Ellenbrook Area Residents Association – Response to Brett’s Drainage Technical Memorandum August 2023

SLR/Brett Technical Memorandum for the HCC, LLFA (Lead Local Flood Authority) project No 403 009885 00024.

Operational Predicted Water Volumes:

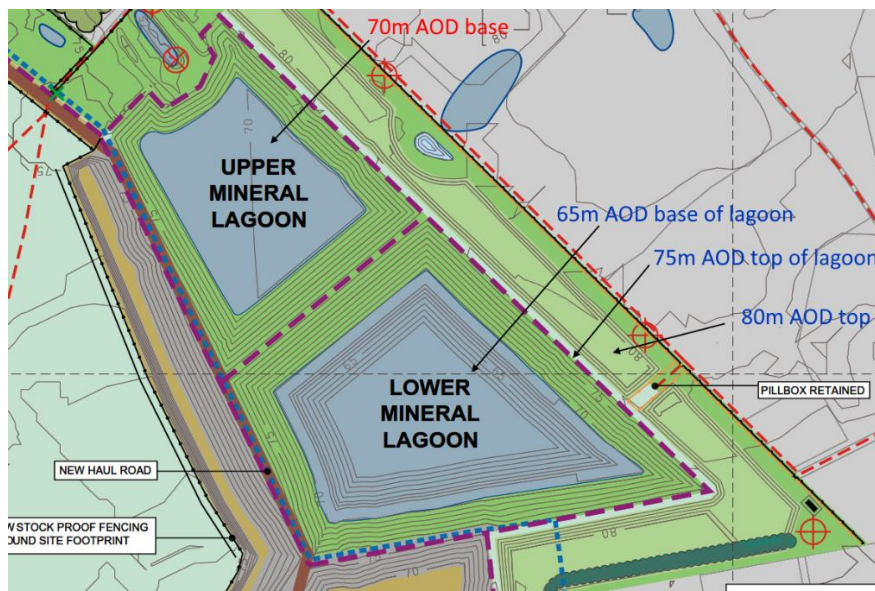
LML or SRL: designed to dewater LMH; discharge = ??????????
capacity to infiltrate back into LMA aquifer = 6,000 – 9,500m³/day

The infiltration rates for the UMH lagoon are not fast enough in the event of a storm. In the event of a storm, the surge in rainwater runoff of 439.2m³/hour would exceed the infiltration capacity of the lagoon and eventually start to overflow the lagoon.

In our example, 50mm of rain falling on The Plant Site (11ha) for two hours would produce 9250m³ runoff. This event would be a tipping point and eventually overwhelm the already filled lagoons.

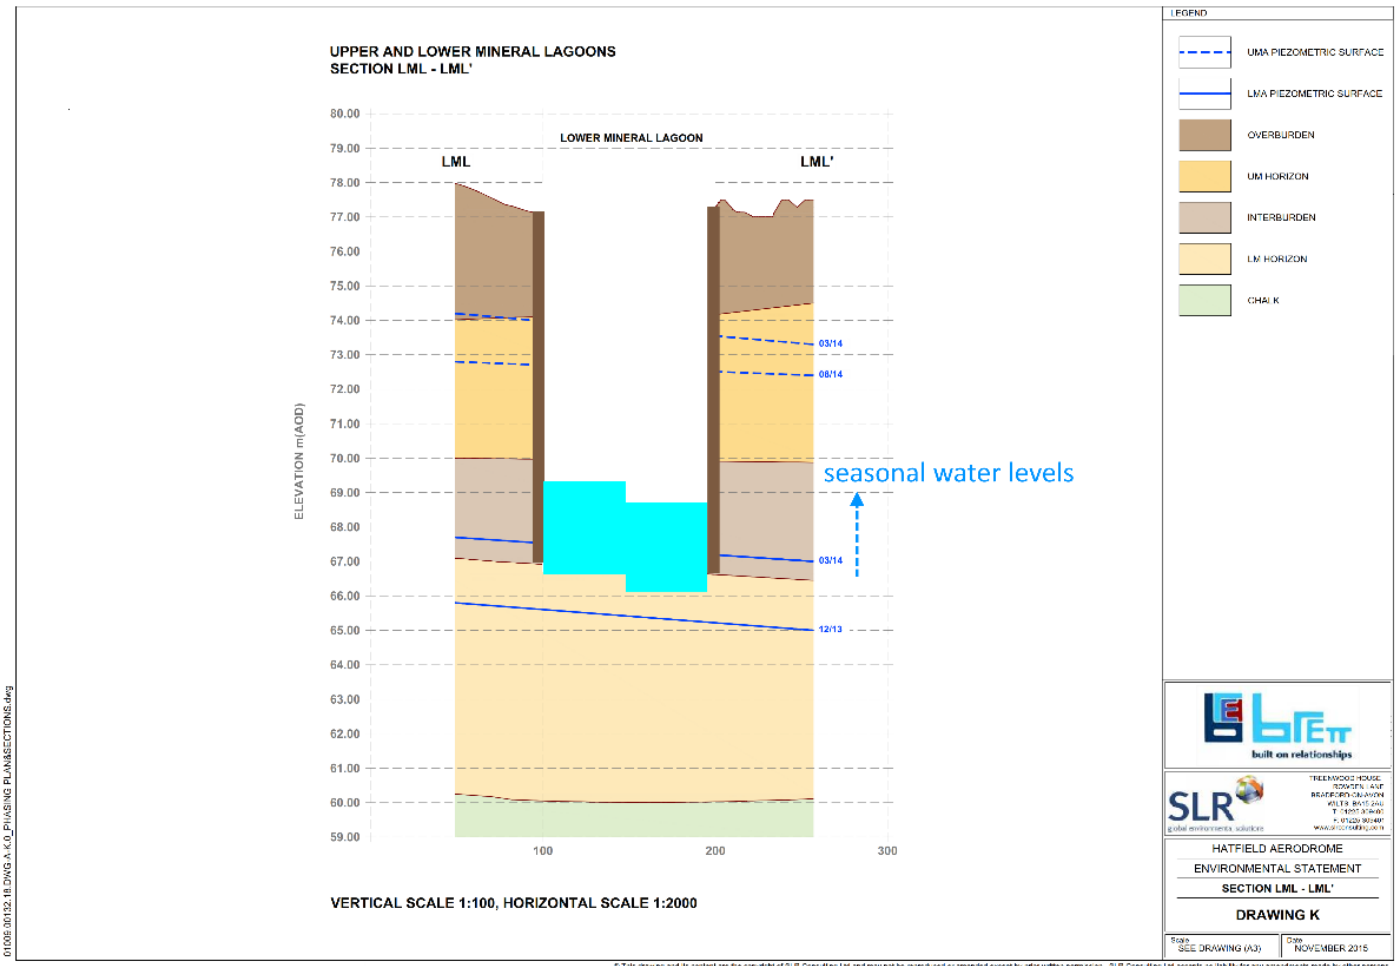
The lagoons layout in the S.E of the site. The UML base is at the top of the interburden, the LML base is below the interburden.

At the Appeal the hydrology team produced a recommendation that **no water from the LMH would be stored in the LML or SRL.**

We understand from this document that for restoration this lagoon will be filled with gravel and the depth brought up to the UML to form one large lake. This is against EA policy to prevent mixing of the aquifers.

There is no reason to have a second lagoon as no LMH water from excavation is being recharged into it. It is also a risk that nearby bromate contamination may infiltrate the lagoon itself, an issue that is against the planning conditions.

The above graphic shows to scale the LML depth, where the seasonal variation of water only fills 1/4 of the lagoon. This lack of water will go on in time to causes dryness and cracking in the walls of the lagoon, risks leakage into the upper aquifer and contaminating it.

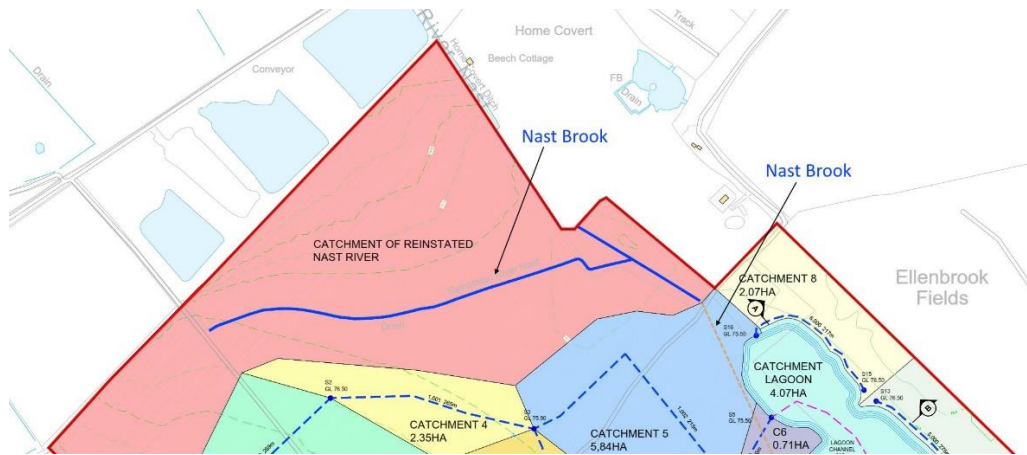
The Nast is **not** a River, it is an ephemeral small brook. Below, the picture shows the Nast culvert emerging from under the A1057 roundabout (not blocked at the time)

“We also note that the culverted section of the River Nast may be blocked or partially blocked, and that the upstream end of the culvert floods during heavy rainfall. As this relates to a main river, we would recommend that the applicant discusses this with the Environment Agency for their requirements.”

The Nast catchment area

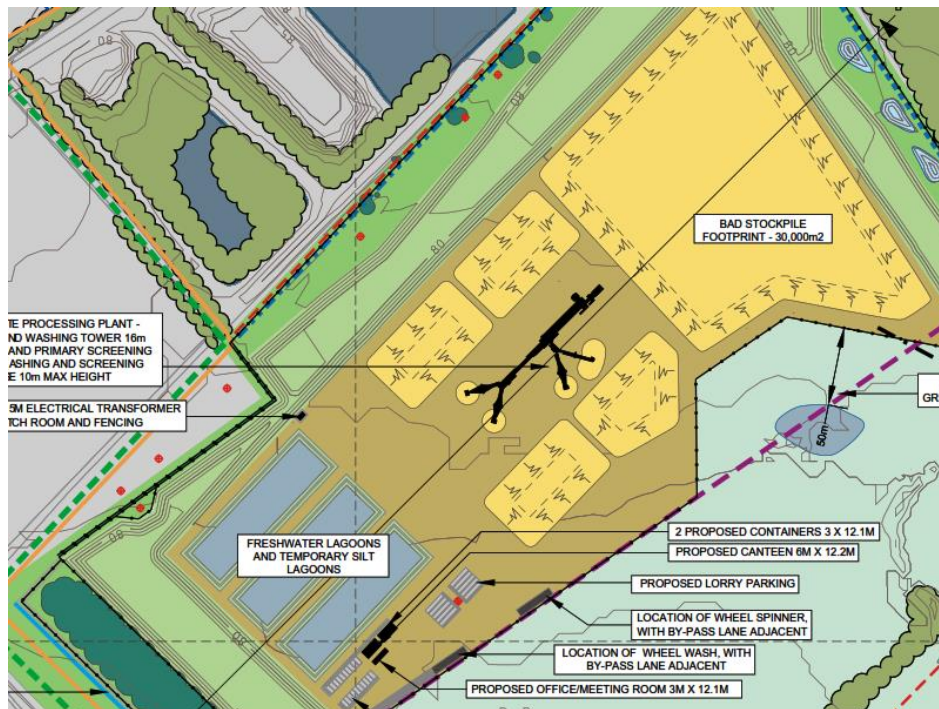
The above maps show the Nast catchment area and the proposed plant area. Drainage from this hard gravel site is given during quarry active period and before the quarry:

A one hour storm produces a large amount of water runoff from the plant site, a runoff of 4625m³, this is then made to flow unattenuated into the Nast.

In the restoration period extra water is added at point MH1 of 5988.3m³. A connection to the Nast is made during the active phase of the quarry development and acts as an overflow in the event of a storm event.

The Nast (unattenuated) flowing south-east now joins the overflow from the lake at MH01, contributing to potential flooding downstream.

In the above diagram the runoff and combined overflow is channelled (brown dotted line) into a culvert along the A1057 road and downstream to combine with the Ellen brook in Ellenbrook Lane.

The University, A1057, and the urban area is now under threat from flooding as the small clavated section cannot take the extra water load.

Map of an active quarry in phase C

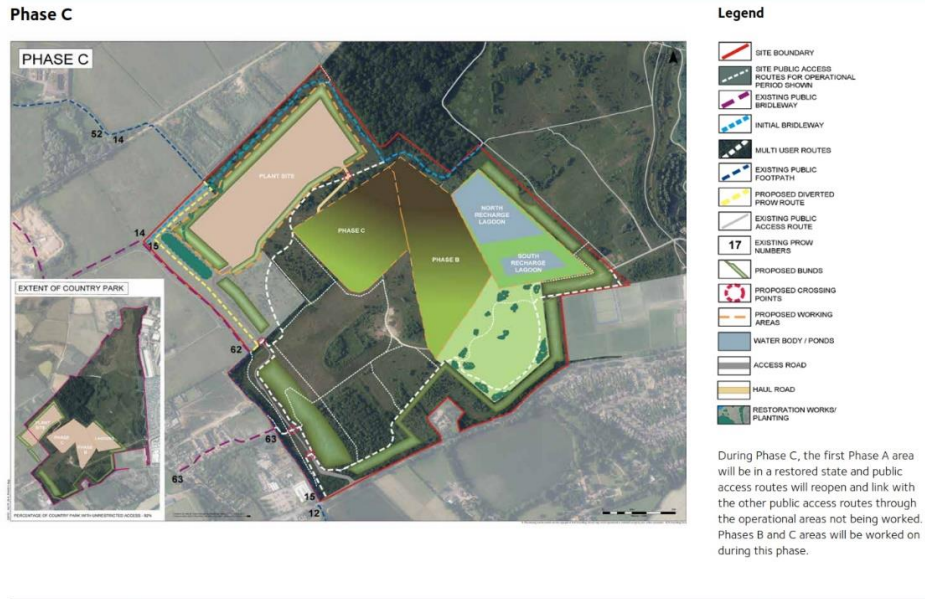
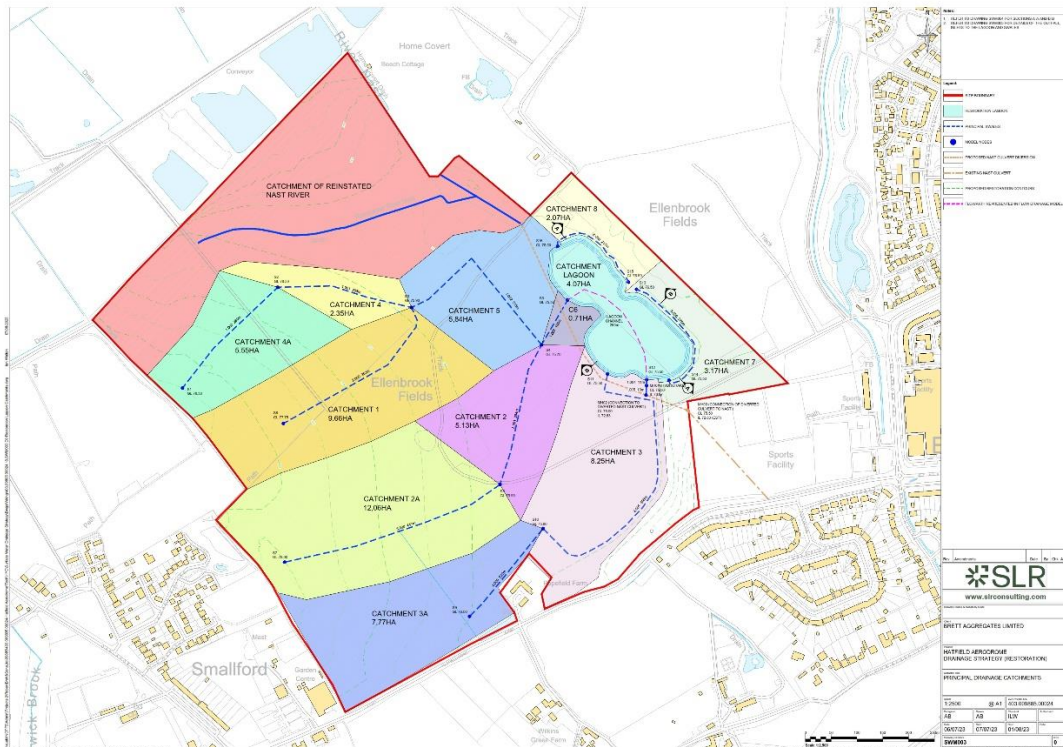
From the two maps above the drainage cannot be complete until the last phase G is finished, and restoration begins. Meanwhile, there is a risk of flooding before restoration to the University of Hertfordshire, A1057 road and the urban areas of Ellenbrook, Hatfield.
